GEORGIAN PLACE SUBDIVISION

Engineering Comments: FINAL PLAT COMMENTS (should be addressed prior to submitting the FINAL PLAT for review and/or signature by the City Engineer):

APPLICATION NUMBER 9 DATE December 21, 2017
 APPLICANT Georgian Place Sudivision
 REQUEST Subdivision

GEORGIAN PALCE SUBDIVISION

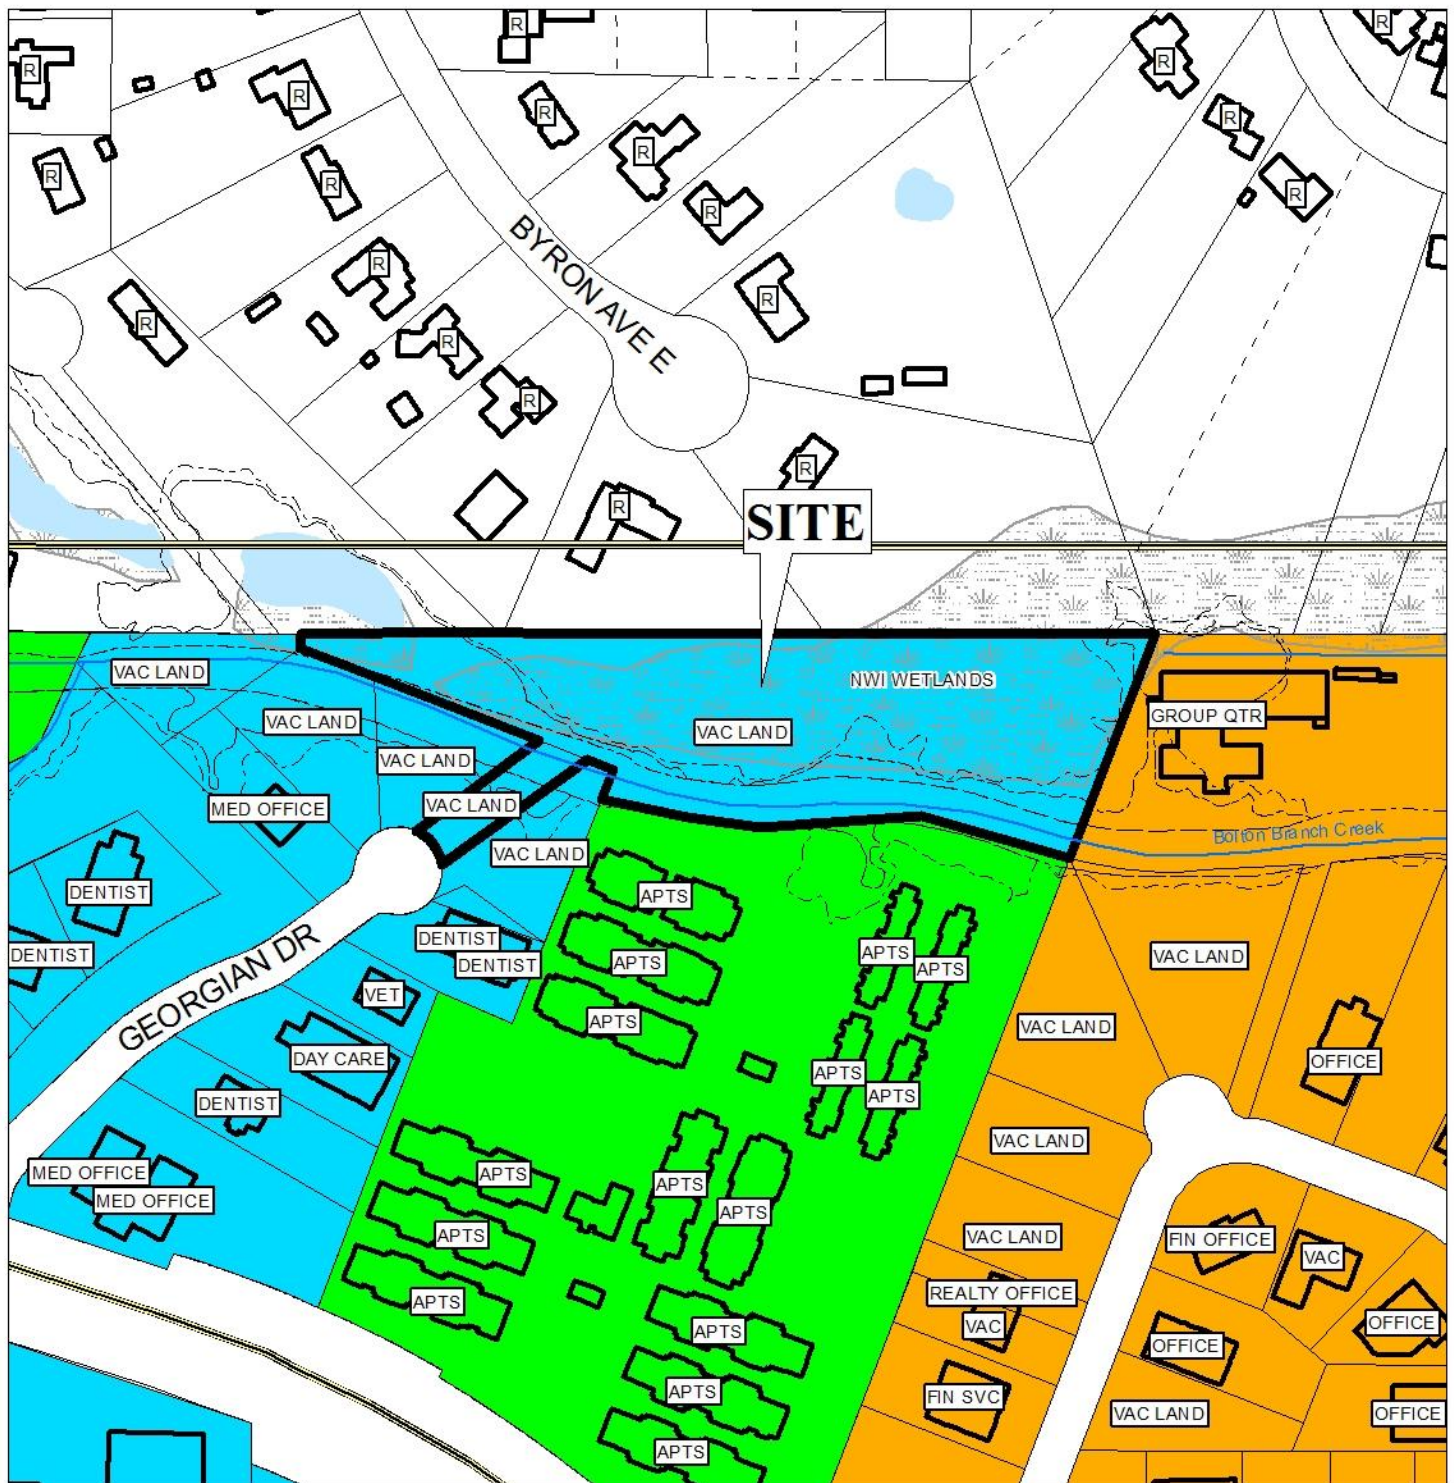
A 25’ minimum building setback line is depicted along Georgian Drive, where the lot is only 50’ wide. If approved, this setback should be relocated to where the lot is at least 60’ wide.

Regarding access management, if approved, a note should be placed on the Final Plat stating that the site is limited to one curb cut to Georgian Drive with the size, location and design to be approved by Traffic Engineering and conform to AASHTO standards.

- 1) relocation of the 25’ minimum building setback to where the site is a minimum of 60’ wide;
- 2) retention of the lot and “greenspace buffer” sizes in square feet and acres on the Final Plat, or provision of a table on the Final Plat providing the same information;

- 3) placement of a note stating that the lot is limited to one curb cut to Georgian Drive with the size, location and design to be approved by Traffic Engineering and conform to AASHTO standards;
